Re: Railway (Metrolink - Estuary to Charlemont via Dublin Airport) Order [2022]
Metrolink. Estuary through Swords, Dublin Airport, Ballymun, Glasnevin and City Centre to Charlemont,
Co. Dublin

Re: Railway (Metrolink–Estuary to Charlemont via Dublin Airport) Order 2022

Case Reference Number NA29N.314724

Figure 19: Southern End Ventilation and Exhaust System (outline in red)

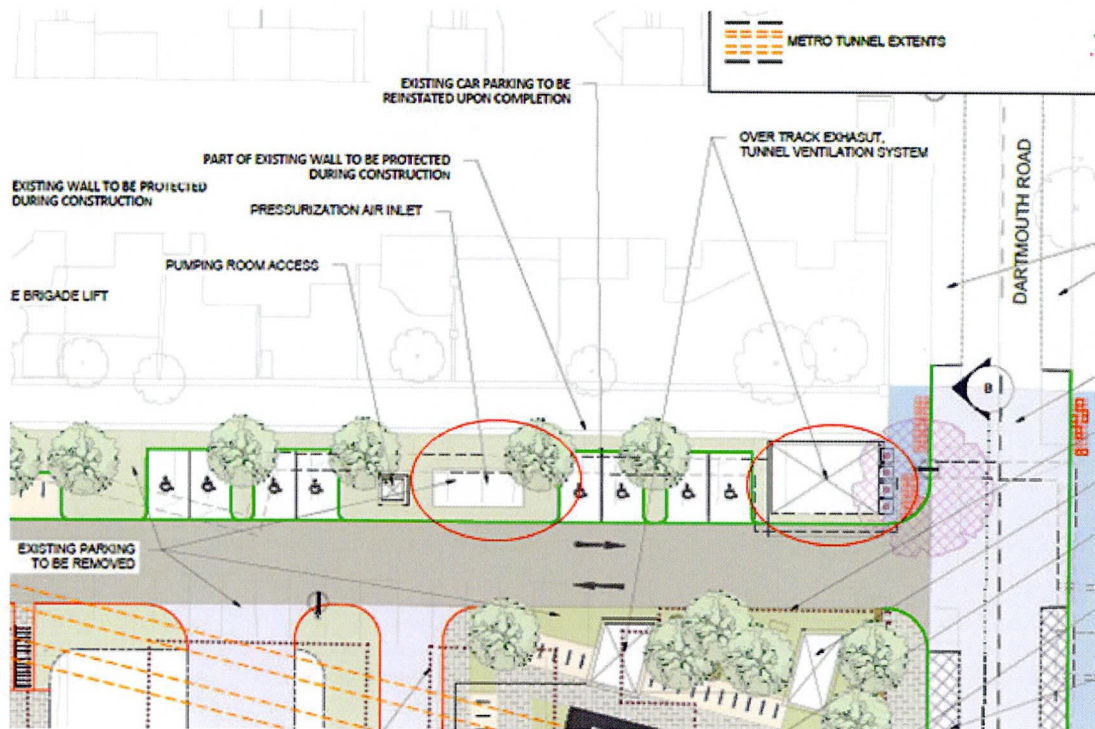
No. 1 Dartmouth Square, my property, will be affected by the location of the vast Southern Entrance Plaza and the Tunnel Ventilation Exhaust ducts located behind the boundary wall.

Item 15 Metro Over Track Exhaust - Tunnel Ventilation System located behind No. 1 Dartmouth Sq.

Figure 2: Charlemont station Surface Layout

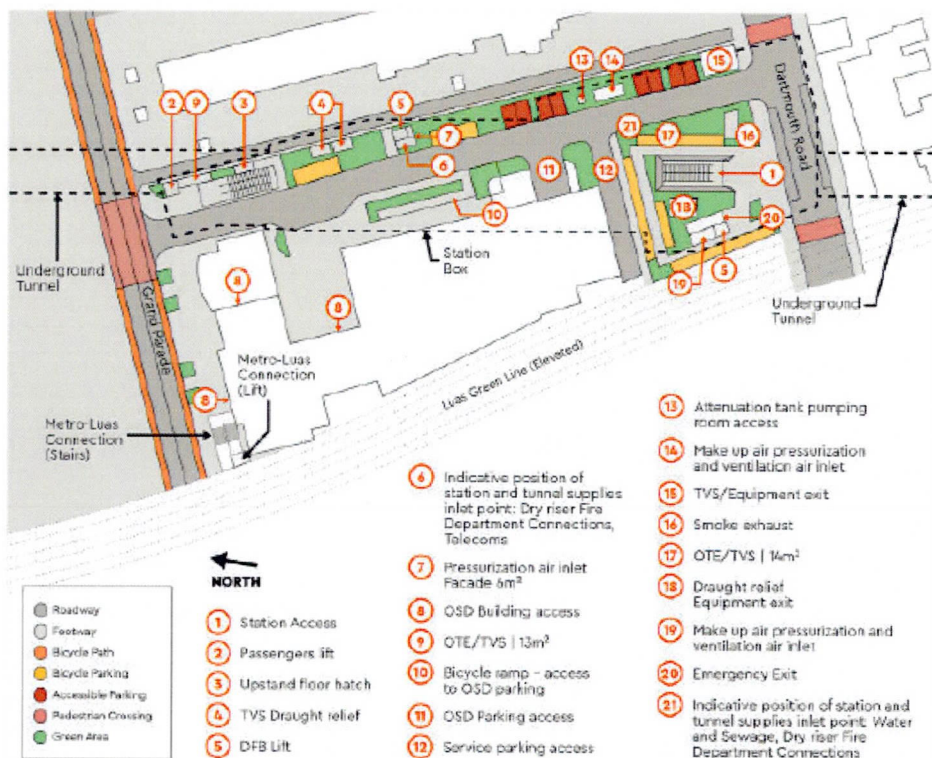
Charlemont Metro Station Plaza - South Entrance located at rear of No. 1 Dartmouth Square .
